Project Name: _____ Building raise + construction, 110 Grill _____

Project: 110 Grill Restaurant
Project Location: 252-256 Main Street, Frontage of K-mart Lot
Memorandum Date: 11-19-15

Subject: Site Plan Special Permit – 110 Grill – 252-256 Main St – SPSP #09/11/15-457 – 2nd & 3rd revisions

Subject: Site Plan and Use Special Permit Application #9/11/15 – 457
Review of Revised Plans and Information Submitted on 11/05/15 and 11/25/15

① EAST (MAIN ST. ELEVATION)
 1/4" = 1'-0"

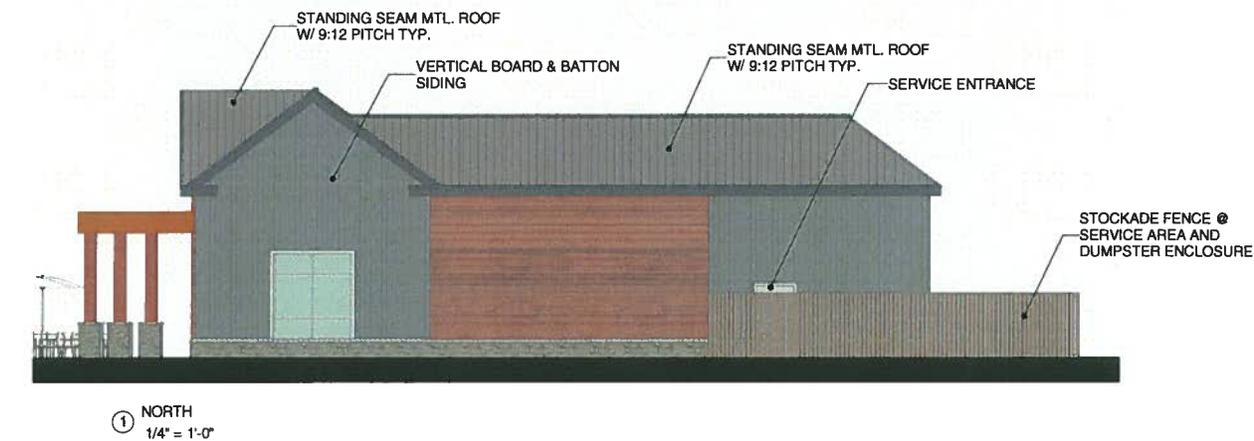
- (l) 20% of the ground level portion of the building's front façade surface must be windows. Approximately 16.5% of the total building's front façade is covered by windows. The Applicant should verify that the ground level portion of the buildings front façade complies with this section or modify the design.

NOTE:
 FACADE FACING THE STREET IS 28% GLAZED AT GROUND LEVEL

The plans have been modified; the front façade surface has 28% coverage by windows.

LANDSCAPE PLAN

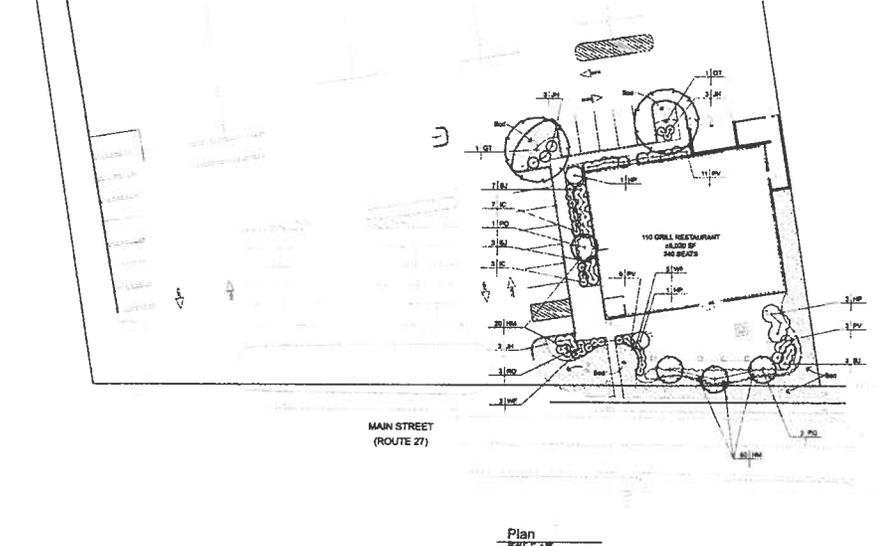
8. The landscape plan has not been revised, and no plantings have been added to screen the north wall as suggested. The neighboring lot has trees along this border which will partially screen; the addition of shrubs on the 110 Grill lot in this location is recommended. The remainder of the plans seems appropriate for the space and use.

GRADING,
 DRAINAGE, AND
 UTILITY PLAN

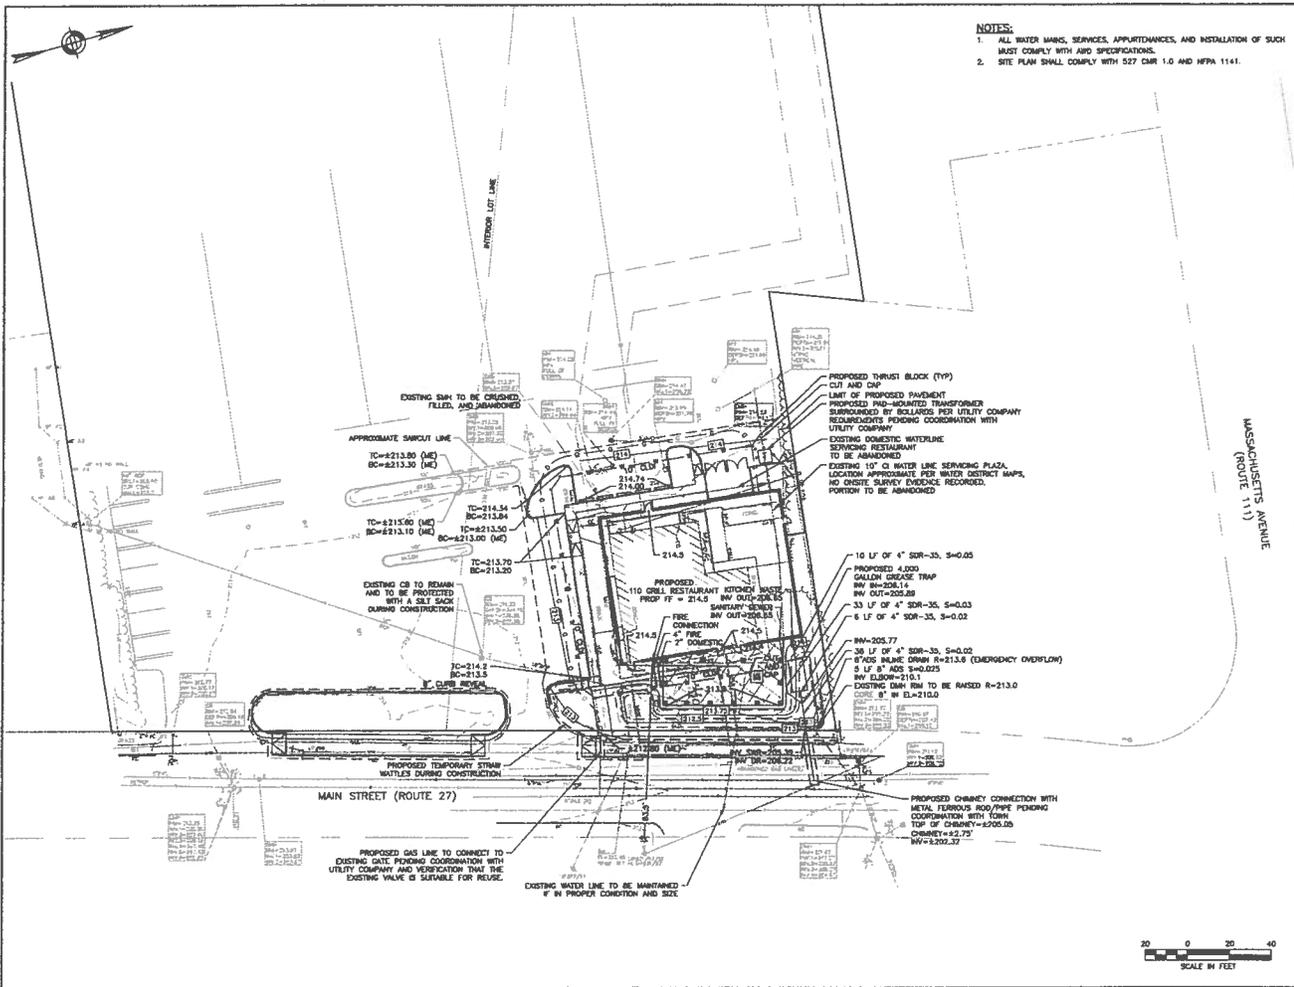
1. The proponent has not sited the building parallel to Main Street as recommend by the DRB. If this is not possible due to lease lines, the DRB suggests it is possible to stay within the lease lines and have the front of the building parallel to Main Street. This would improve its relationship to the street and surrounding buildings.

2. The outdoor eating area as revised is parallel to the street but is does not seem enlarged as recommended by the DRB recommendation.
3. The building entrance and pedestrian space outside of the door are appropriate.

4. The sidewalk along the south side has been narrowed to 5 feet from 6 feet contrary to the DRB's recommendation to widen the walk. The DRB recommends widening this walk.

7. No change has been made regarding vehicular entrances. The DRB recommends combining the two entrances into the lot into one drive in a central location.

5. The modified parking lot along the south side of the proposed building is located +/-20ft from the property line where a 30ft setback is required under ZBL S. 6.7.2. The parking space closest to the street should be removed.

7. ZBL S. 6.7.6 requires a minimum 10-foot wide perimeter landscape buffer for parking lots. The perimeter landscape between the modified parking lot and the proposed restaurant only shows a 9ft wide landscape area. The landscaped area should be widened to comply.

The plan has been modified to comply in this location.

Although the location above has been modified to comply, the 10-foot wide perimeter landscape buffer has been removed and a pedestrian plaza has been placed next to the parking lot cells. The Applicant should amend the plans by adding a 10-foot wide perimeter landscape buffer to boarder the parking lot cells. A pedestrian plaza cannot count towards the required 10-foot wide perimeter landscape buffer. Parking calculations should be revised to show changes.
